VERTICAL BLOCKING DIAGRAM FOR GIRDER LINES 1 THRU 5

ITEM NO. 506.55	BR. NO. 3	PROJ. NO. BRZ 1444(22)
TITLE: BLOCKING DIAGRAMS		
APPROVED:		
PRINT DIST.		
5	4-7-01	APPR.
ORIG.		FAB.
5	7-13-01	APP
5	8-24-01	APP
JOB: T.H. 1 OVER THE WHITE RIVER ROYALTON, VERMONT		
CUSTOMER: BECK & BELLUCCI, INC.		
DESIGNER: VERMONT AGENCY OF TRANSPORTATION		
CHECKED DRAWN	TS AV	3/01 3/01
WORK ORDER NO. 15873		DRAWING NO. 70-1
		REV. A

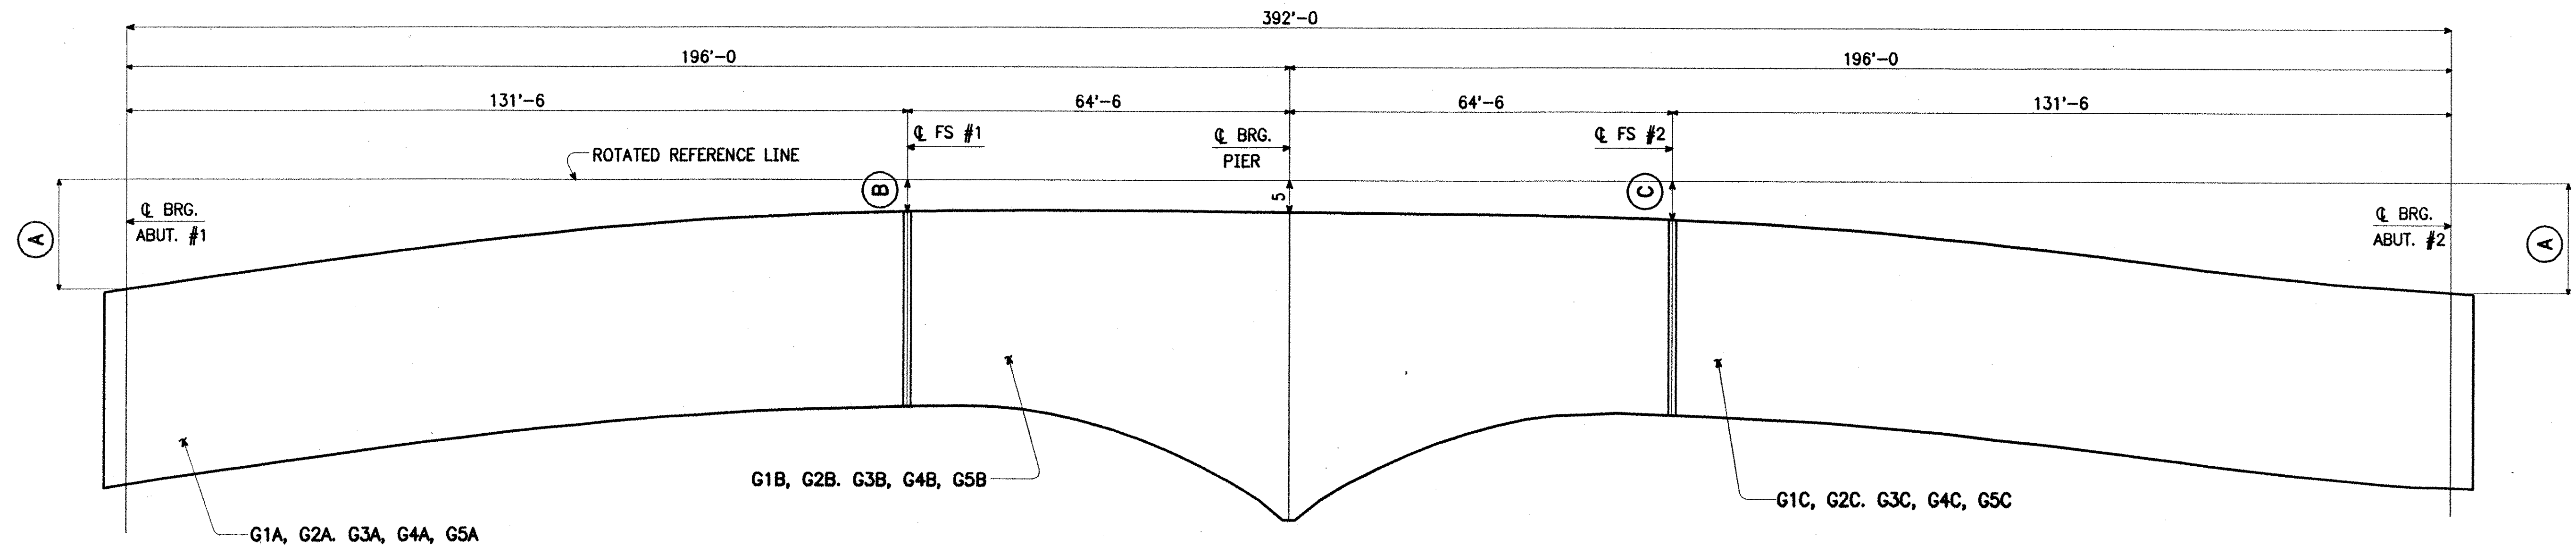
RECEIVED
CHK'D BY *WES* OK'D BY
AUG 27 2001
RESUBMIT BY *CPW* APPROVED *✓* DATE 8/28/01

OK
